24-37SP Border Road Storage

Staff Report

Address:	2114 N. Border Road
Requests:	Construction of two 3-story self-storage buildings
Owner:	Dan Lussier
Agent:	John F. Cavoli, P.E.
Parcel IDs:	0390-00-3020
Parcel Size:	±5.274 acres
Future Land Use:	Commercial
Zoning:	Commercial
Comprehensive Plan Neighborhood:	Northeast Venice
Application Date:	June 17, 2024

Site and Development Plan

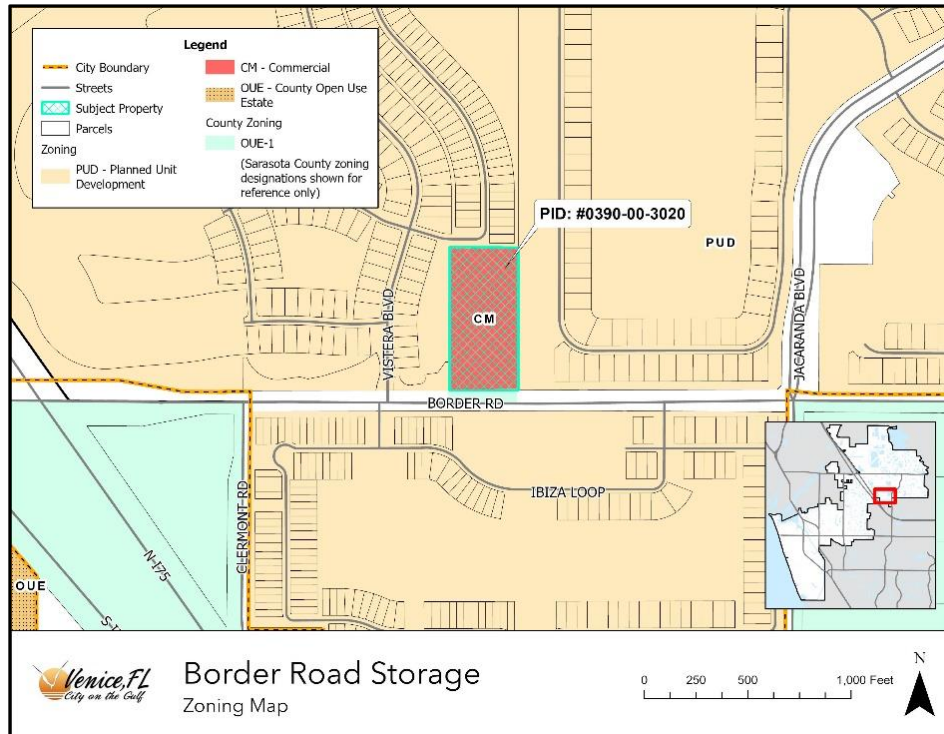
The Site and Development Plan proposes constructing two 3-story indoor self-storage buildings. The proposed project has been reviewed for consistency with the LDC. The proposed plan, aside from parking (alternative parking plan provided), complies with the LDC and has been reviewed for compliance with regulations on use, setbacks, land area, height, lot coverage, lighting, and landscaping requirements.

The applicant has provided an alternative parking plan, which is included as an agenda item for this petition. The code required parking for a development of this size would be 107 spaces, at 0.5 spaces per 1,000 square feet. The applicant is requesting 74 spaces, which is more in line with the ITE parking requirements for self-storage/mini warehouse. At 0.1 spaces per 1,000 square feet, that would require 21.4 spaces for a development of this size. The alternative parking plan will need to be decided on by the Planning Commission as it is a parking reduction of 31%.

Summary Staff Comment: *The site and development plan is compliant with all relevant sections of the City's Land Development Code, other than parking, for which the applicant has submitted a alternative parking plan. The proposed site and development plan conforms to the approved binding concept plan, which was evaluated through the zoning map amendment process. During*

Architectural Elevations

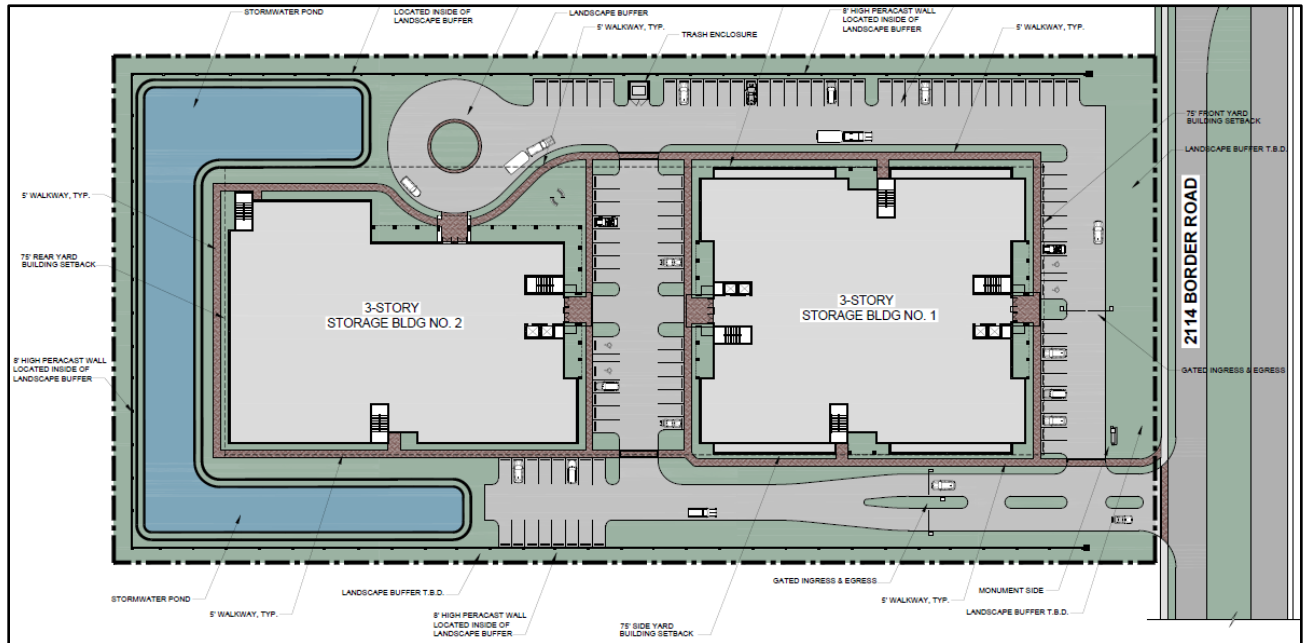
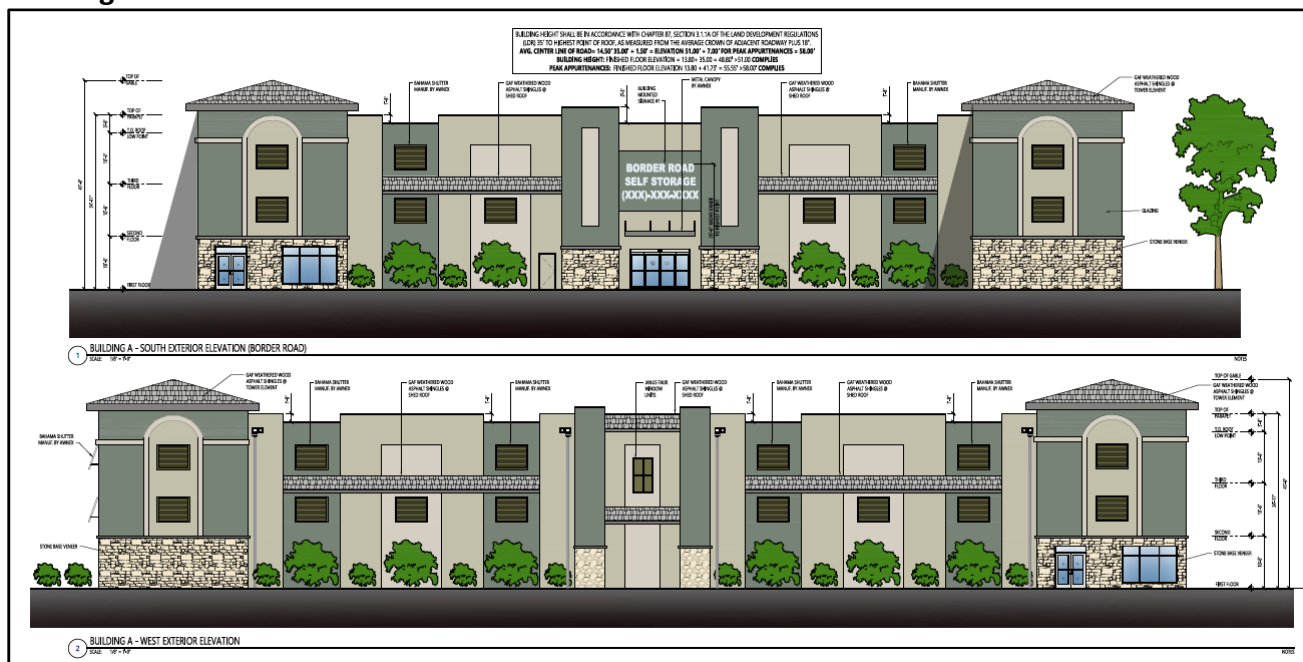
Staff comment: *Applicant has provided a significant number of Venice Historic Precedent (VHP) elements to the building. Additionally, as indicated in prior meetings for the annexations, rezone and comprehensive plan amendment petitions several mitigation measures have been taken, including minimal signage and shutters for the windows to reduce glare. Tile roofing will not be present as indicated in the applicant comment; however, it should be noted that the conceptual plan does not specifically note tile roofing.*

Staff Comment: *The proposed site and development plan provides some VHP elements and several design elements such as shutters on the windows to lessen glare and reduced signage to align with comments made in prior meetings by decision makers and public stakeholders.*
